Access Compliance Report

Public Rights-of-Way

(Curb Ramps)

Intersection ID: 16755	Main Street: DICKINSON_PL	Cross Street: PRINCETON_AV	Location: SE
ADA ID: A04E6F71ED09	Ramp Type: Directional1	Initial Pass/Fail: Fail	Overall Compliance: No
Codes/Mitigation Info/Possible Solution		Field Measurements/Component Compliance	
Severity Score: 13.75

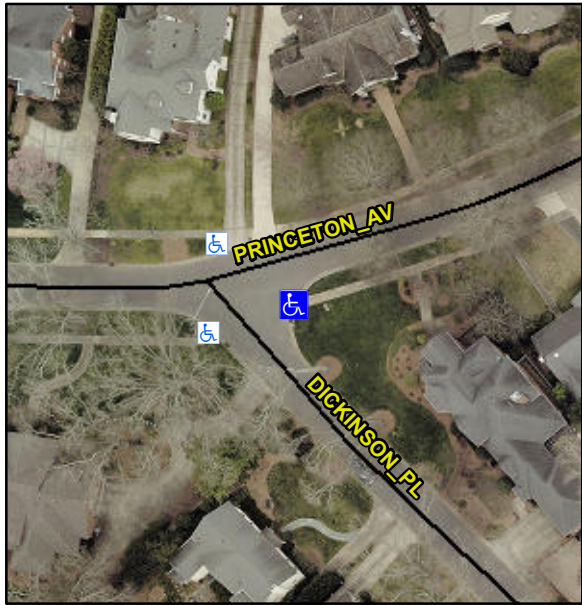
Possible Solutions:				
	Remove & Replace Entire Ramp.				
	Surveyor Notes:				
	N/A				
	PROW/ADA:				
	R304.2.2, R304.5.3				
	Street 1 Name		DICKINSON PL		
	Stop Condition-Street 1		StopSign		
	Street 2 Name		N/A		
	Stop Condition-Street 2		N/A		
Total Cost:		\$	1600.00

Compliance	Description	Data	Compliance	Description	Data
N/A	Ramp Length (in)	24.5	N/A	Grade Break?	N/A
Yes	Ramp Width (in)	58.0	N/A	Grade Break Slope (%)	0.0
No	Ramp Slope (%)	8.6	N/A	Grade Break XSlope (%)	0.0
No	Ramp XSlope (%)	2.1			
N/A	Flare Type LT	N/A	N/A	Flare Type RT	N/A
N/A	Flare Slope LT (%)	N/A	N/A	Flare Slope RT (%)	0.0
N/A	Flare Traversable LT?	N/A	N/A	Flare Traversable RT?	N/A
N/A	Landing Length (in)	0.0	N/A	DWS Provided?	N/A
N/A	Landing Width (in)	0.0	N/A	DWS Contrast?	N/A
N/A	Landing Slope (%)	0.0	N/A	DWS Length (in)	N/A
N/A	Landing X Slope (%)	0.0	N/A	DWS Full Width?	N/A
N/A	Landing Curb? (Y/N)	N/A	N/A	DWS Offset LT (in)	N/A
N/A	Shared Landing?	N/A	N/A	DWS Offset RT (in)	N/A
N/A	Gutter Ponding?	0.0	N/A	Gutter Slope (%)	N/A
N/A	Gutter Lip Ht (in)	0.0	N/A	Gutter X Slope (%)	N/A
N/A	Painted X Walk1?	No		Road Slope (%)	4.5
	X Walk 1 Direction	To SW		Road X Slope (%)	2.9
	X Walk 1 Width (in)	N/A		Clear Space?	N/A

X Walk 1 Slope (%)	4.5	N/A	Clear Space to XWalk (in)	N/A
	X Walk 1 X Slope (%)	2.9	N/A	Storm Grate/Utility Hazard?	N/A
N/A	Ramp inside XWalk1?	N/A		Storm Grate/Utility Type	
N/A	Any Obstructions?	N/A			N/A
	Obstruction Type		Yes	Surface Condition? (G/P)	Good
		N/A	N/A	Curb Slope (%)	22.4
